STRATEGIC PETROLEUM RESERVE

ENGINEERING CHANGE PROPOSAL

ECP NUMBER	TITLE:
SJ-M/O-4626	**Disable Oil Stop Valve**

ECP NUMBER	ECP TITLE	PAGE 1 OF 4
SJ-M10-4626	Disable Oil Stop Valve

OIL STOP VALVE
BOX SJT-V-1
MECHANICAL PACKAGE
ST. JAMES TERMINAL
ST. JAMES PARISH, LOUISIANA

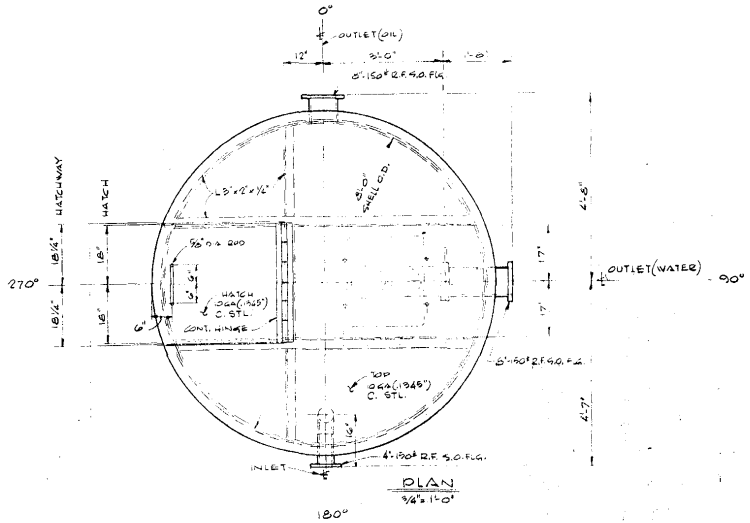
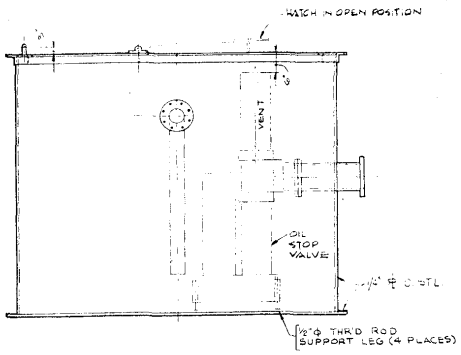
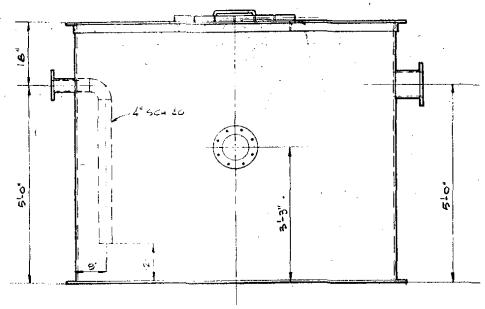
The Oil Stop Valve in the Oil Stop Valve Box SJT-V1 has malfunctioned in the past causing the Oil Sump SJT-S3 to flow.

Disable the Oil Stop Valve by removing the float assembly.

The Oil Stop Valve is located upstream of the Dock Oil Water Separator SJT-SEP1. Its function is to prevent a solid stream of crude oil from reaching the Separator. However, when the device fails all rainwater collected on Dock #1 and #2 is routed directly to the sump. The sump liquids are pumped into tankage, affecting the crude oil quality. If the Dock Oil Water Separator SJT-SEP1 capacity is exceeded the oil will be contained in the retention pond.
